Summary of electronics Meeting of February 11, 2002

In this 1-hour shortened meeting, a discussion was made of the five K-State Run 2b projects: L0-1 and L2-5 digital jumper cables, junction, adapter and “purple” cards will be discussed in that order, concentrating on relevant comments and decisions.

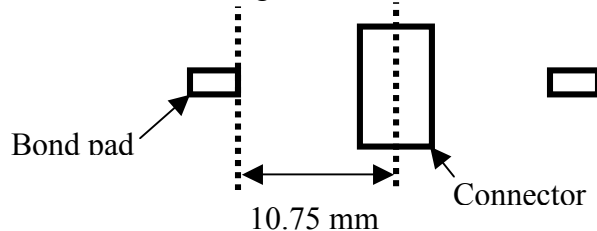
2) Marcel raised the point that the cable ends near the hybrid may require redesign. After the meeting, I talked to Mike Utes, and we measured the following picture:

From the center of the connector to the inside edge of the bond pad is 10.75 ± 0.1 mm by measurement on a 5X life-size drawing. However, it is 11.5 mm from the connector center to the edge of the DJC. Several folks stated that this is too long. After investigating, Noel stated that reducing 11.5 to 10.5 mm was easy, but more was quite difficult. However, there are wire bonds on both sides, and the body of the cable can just as easily flop down onto a wire bond on the right-hand side as can the edge of the cable wreck a wire bond on the left-hand side. Yours truly believes that we need a physical step or some other way, such as potting, to protect bonds on both sides.
